# CITY OF CONWAY, ARKANSAS

December 27, 2021 · 5:30pm · 1111 Main Street

- I. Public Hearing Items Robinson Historic District
  - A. 1832 Robinson Avenue Signage (HDR-1221-0158)
- II. Public Hearing Items Old Conway Design Overlay District
  - A. 908 Chestnut Street Exterior Modification (HDR-1121-0139)
- III. Discussion
- A. Additional items as decided by the Commission Adjourn.

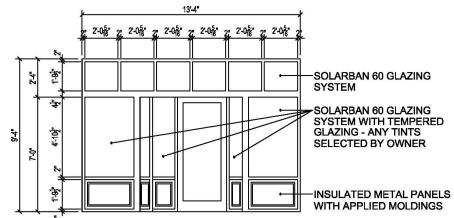
**Façade Articulation.** Façades should be broken into bays with articulation that prevents the appearance of flat, unbroken walls.

The design will improve the appearance of the existing flat wall façade by adding an appropriate storefront.

**Ground-Level Façade Detail.** A minimum of 2/3 of the first floor façades should be windows and all first story windows should be no higher than 3' above the ground.

The design meets this requirement.

1. Staff recommends approval of the new storefront.
